**COMPREHENSIVE PLANNING COMMITTEE MEETING**  
Tuesday, September 20<sup>th</sup>, 2022, 12:00 noon  
**AGENDA**

**RE: Tower Place – Land Use of Regional Significance  
City of Bethlehem  
Lehigh County**

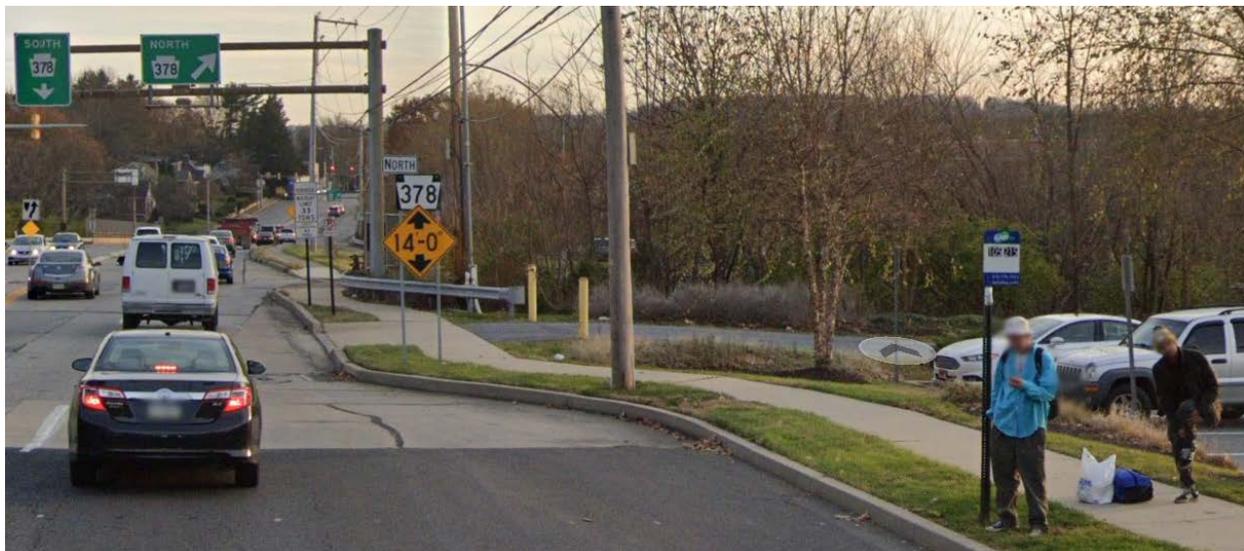
The proposal does not link the sidewalk network into the complex across the parking lots, however. The LVPC recommends that, in addition to including continuous sidewalks on the outside parameters of the development, pedestrian walkways be included in and around the interior of both parking lots. This would 'Ensure transportation accessibility for all persons, 'Improve connections between bus stops and pedestrian and bicycle infrastructure' (of Policy 5.2), and create an accessible area that is well connected for access by everyone.
